## ADDENDUM NO. 1

CONSTRUCTION OF HOPKINS COUNTY SAFETY REST AREA

PROJECT NO. STP 2000(825) TE

ADDENDUM NO. 1 DATED March 30, 2016

CONT	SECT	JOB	HIGHWAY
0009	09	081	IH 30
DIST	COUNTY		SHEET NO.
PAR	HOPKINS		15

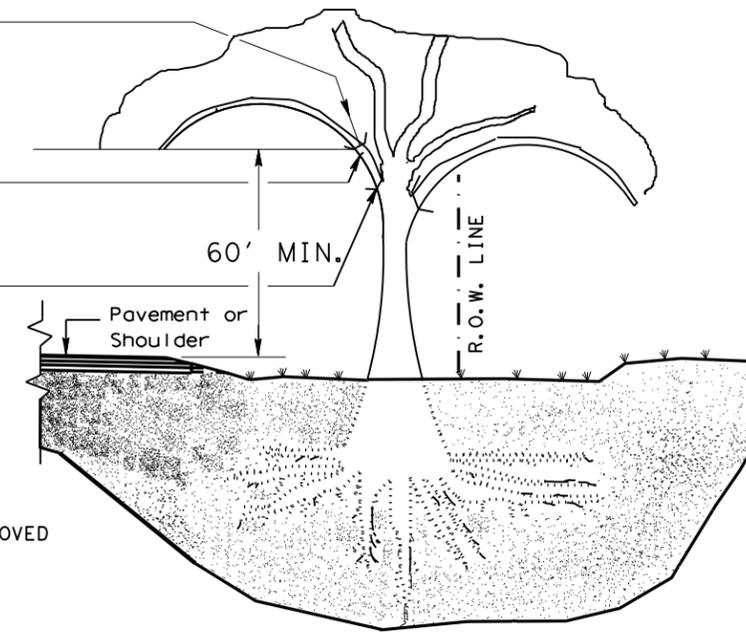
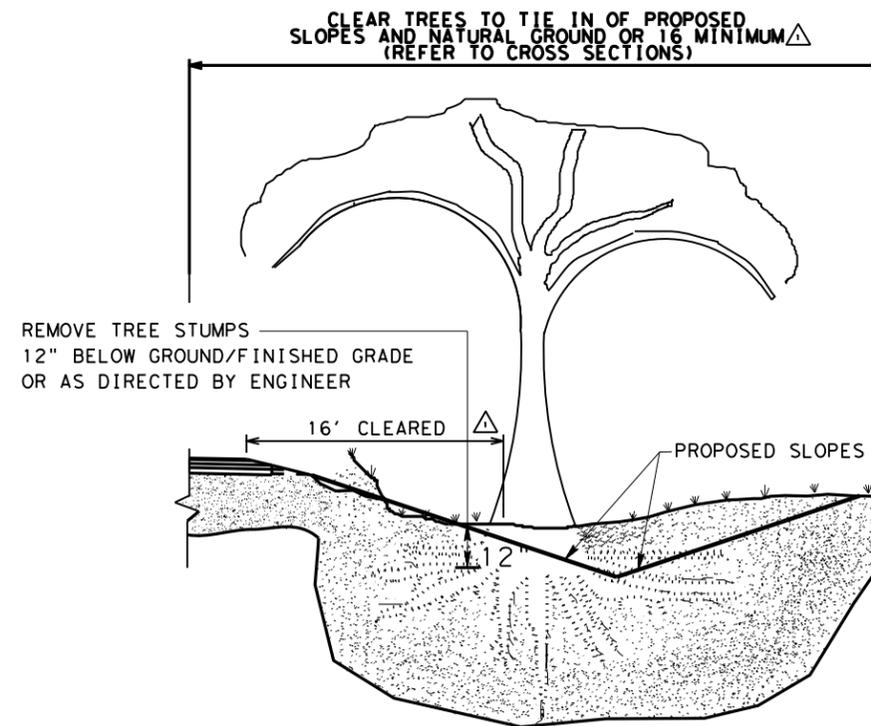
TREE TRIMMING  
 IN VOLUME 1 WORK AREAS  $\Delta$

TREE REMOVAL  
 IN VOLUME 1 WORK AREAS  $\Delta$

13. Sheet 82 of Vol. 1 has a detail for trimming the existing trees with a note that states areas for tree trimming and removal must be indicated in the plans. Do you have these sheets available because there isn't anything in either volume that gives locations or counts to quantify the work needed?

Additionally Volume 1, Sheet 82 will be revised to clarify trimming scope.

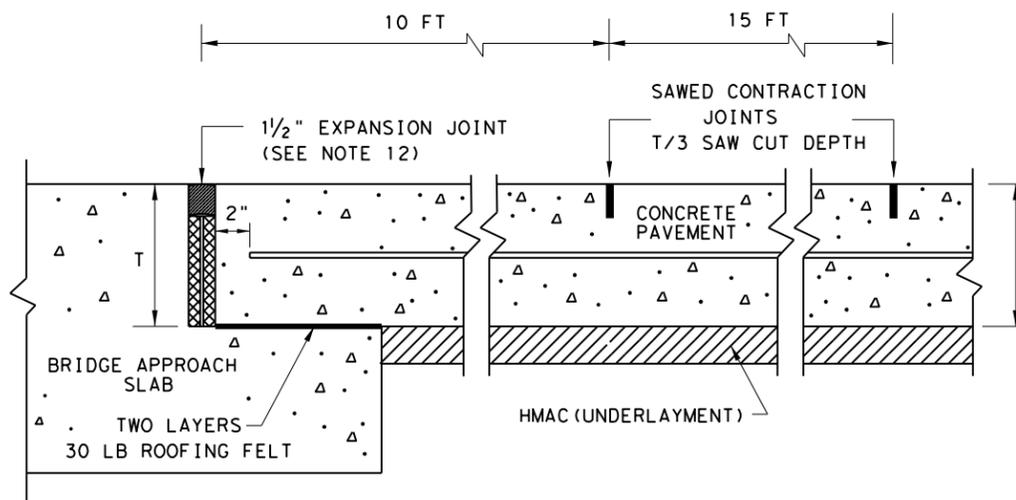
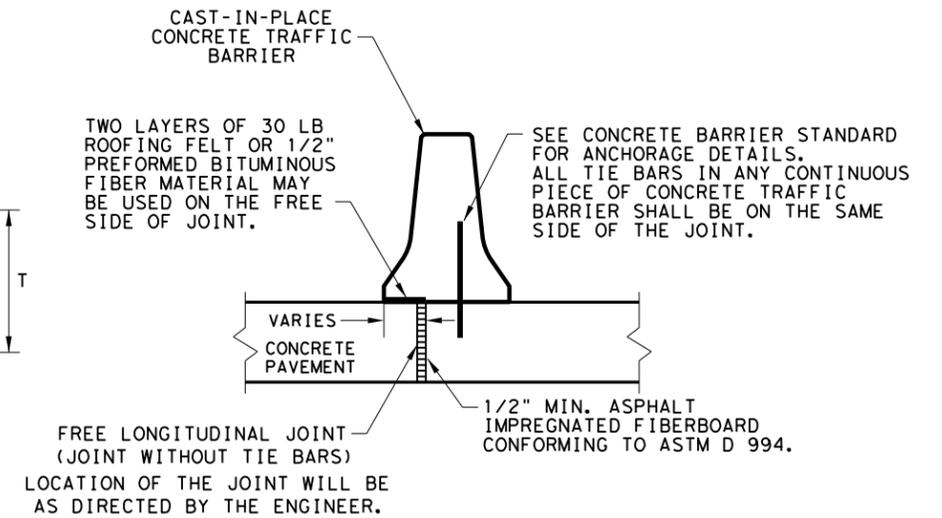
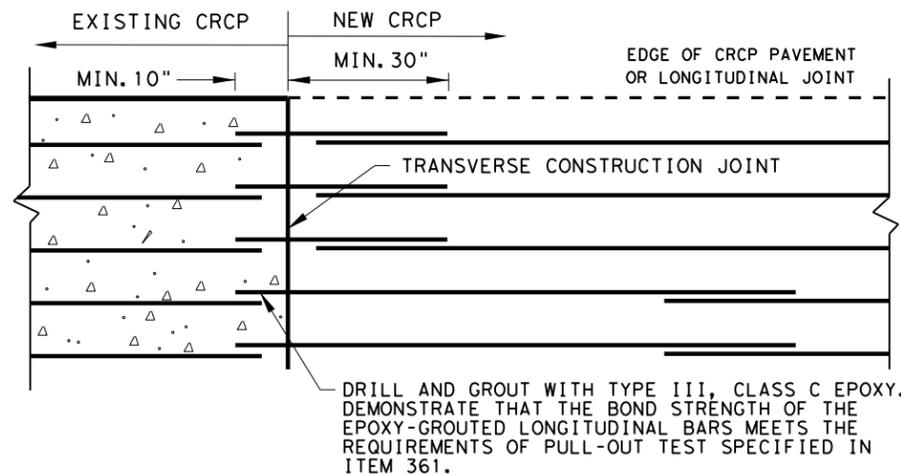
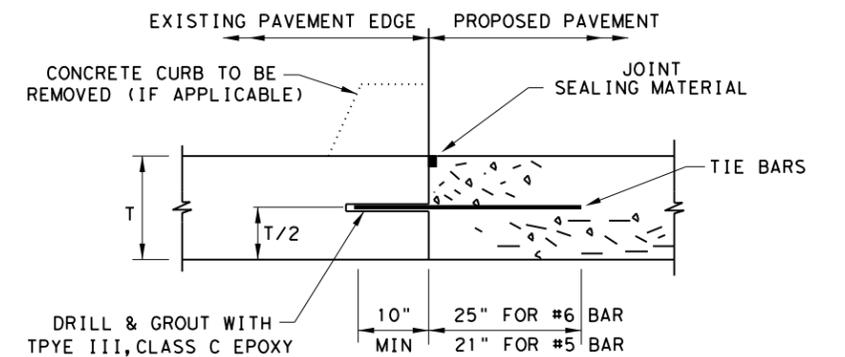
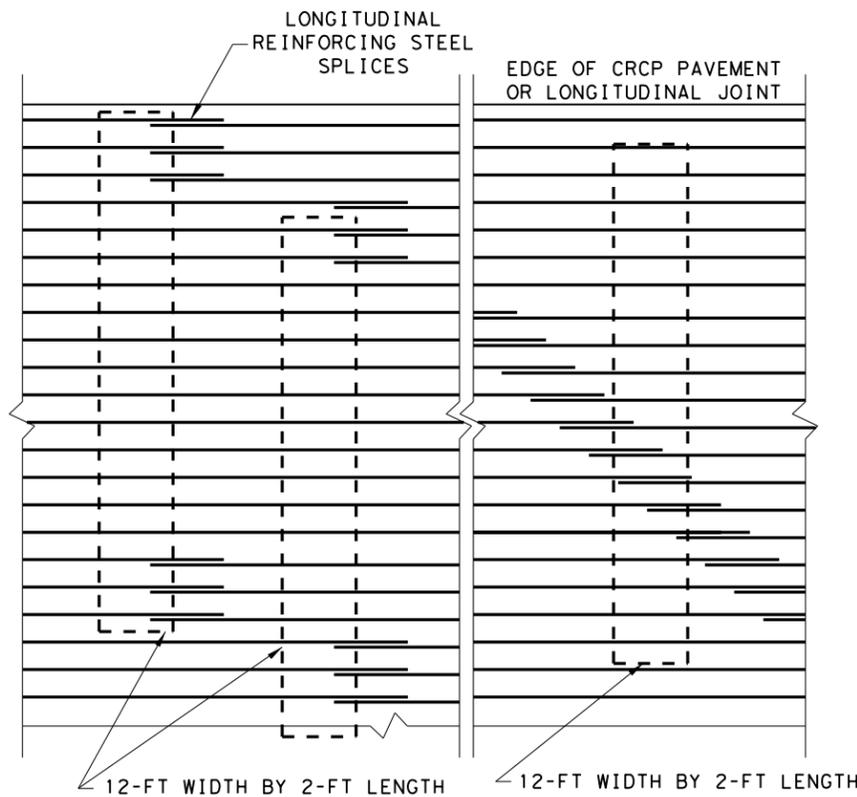
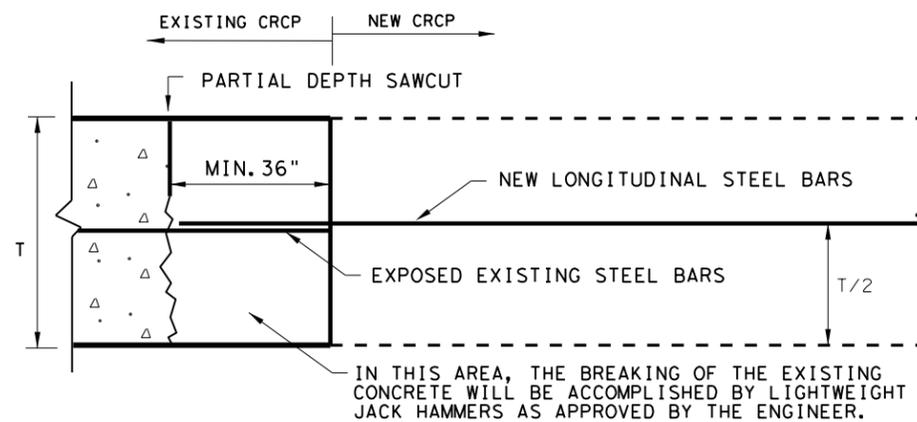
9. Per note #1 on sheet 95 CRCP(1)-13 details of the contract drawings a free longitudinal joint is required at max 100'. The truck parking areas are greater than 100' wide. These areas are to be parking areas, and not a designated highway. Does the free longitudinal joint detail on sheet 95A still apply? If not please provide a revised detail.

responsibilities. Revised Item 502 notes to ensure that both frontage road travel lanes are open at night. Notes shifted.  
Sheet 008E, General Notes, Notes shifted.  
Sheet 008F, Removed duplicate Item 360 notes. Notes shifted.  
Sheet 13, Estimate & Quantity, Revised quantities of Items 110 6001 and 132 6004.  
Sheet 15, Quantity Summary, Revised quantities of Items 110 6001 and 132 6004.  
Sheet 82, Tree Trimming and Brush Removal, Clarified the limits of work.  
Sheet 095, CRCP(1)-13 (MOD), Added Longitudinal Joint Detail. Changed name.  
Sheet 095A, CRCP(1)-13 (MOD), Changed name.

Project No. STP2000(825)TE  
Date SEPTEMBER 16, 2015  
Sheet No.  
**LC 1.01**  
39 of 174 sheets

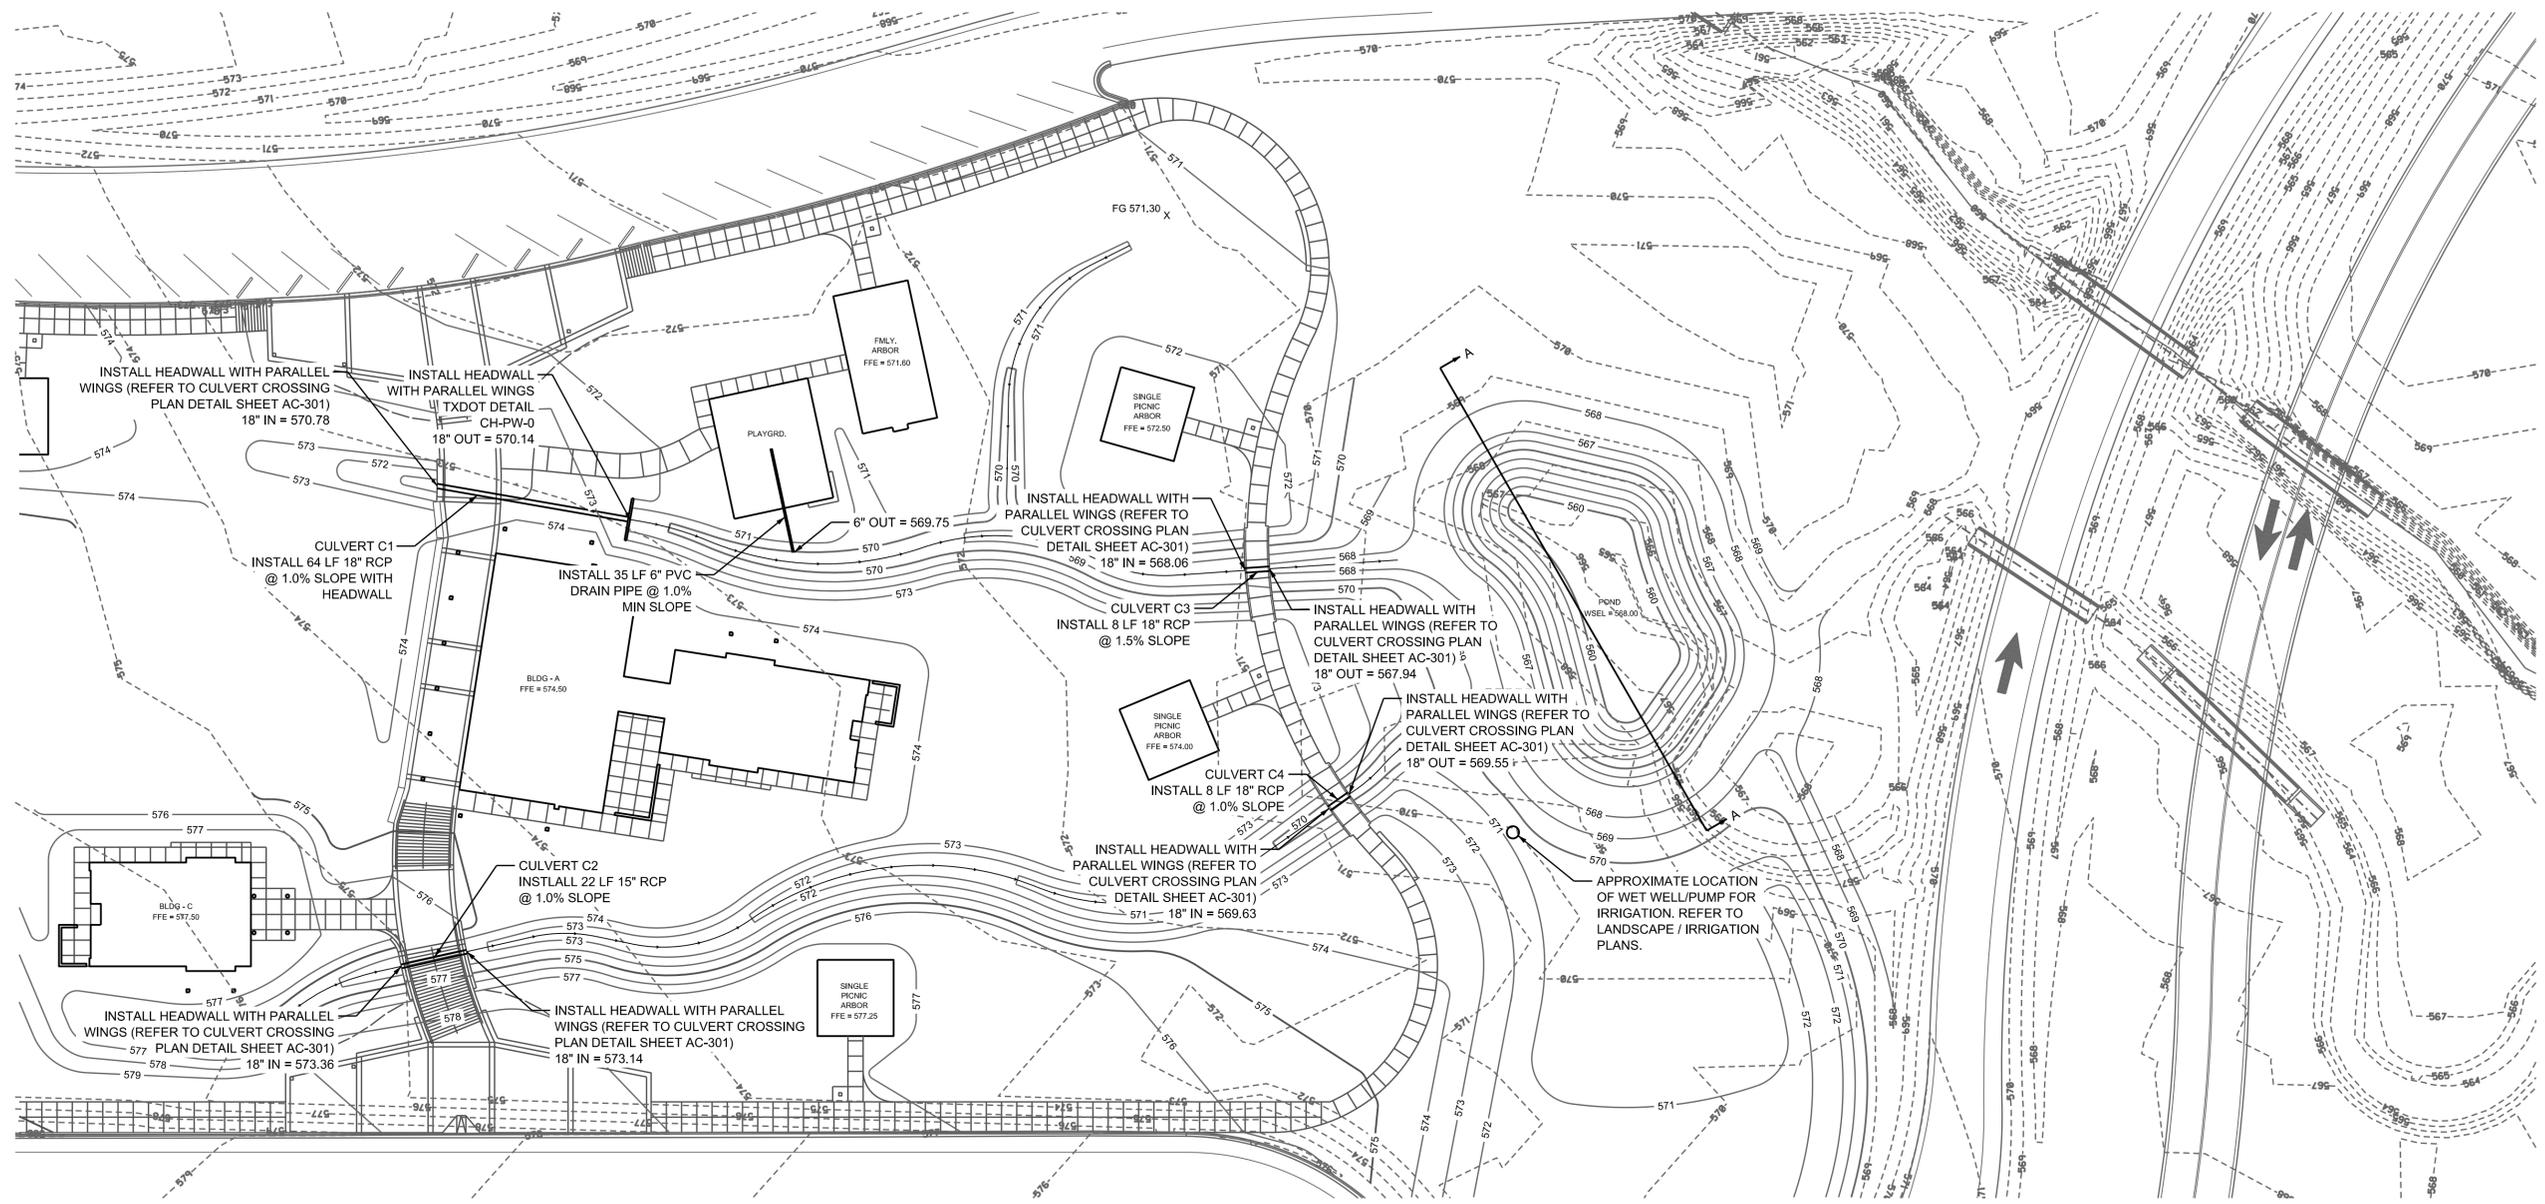
ITEM D2.1 Sheet LC1.01: Replace with revised Sheet LC1.01 attached to the end of the Addendum.

Add General Note 15 as follows: "Landscape Plans call out to preserve existing natural vegetation where grading does not occur. Intent is to leave as much natural vegetation as possible. Where trees and vegetation conflict with new grading, new construction, new landscaping and new site improvements, existing trees and vegetation are to be removed."

Modify Note as follows: "All Landscape scope of work to be bid as line items in Volume 1 specifications unless otherwise noted on this sheet or as referenced in Sheets AC-101 and AC-106."

Notes added to Materials Schedule, Key Note S.5, S.6, S.7 and S.8:

Add the following sentence to the end of Key Note S.5: "Provide 200 tons of boulders in locations as indicated and as field located."

Add the following sentences to the end of Key Note S.6: "Cherokee River Rock and/or West Texas River Rock are acceptable substitutions for the Oklahoma River Rock specified. Provide 200 cubic yards for 6" min. depth over 7,800 SF as indicated and as field located."

Add the following sentence to the end of Key Note S.7: "Provide 100 cubic yards of cobble in locations as indicated and as field located."

Add the following sentence to the end of Key Note S.8: "Provide 90 boulders in locations as indicated and as field located."

Add note to items S.5, S.6, S.7 and S.8 in Material Schedule to indicate these items are to be bid in Volume 2.

7. After looking at the landscaping plans LS 1.01 – 1.06 they refer us to detail 5 on sheet LS 2.01, in no way does this detail represents the boulder lay out

Refer to the revised Sheet LC1.01.
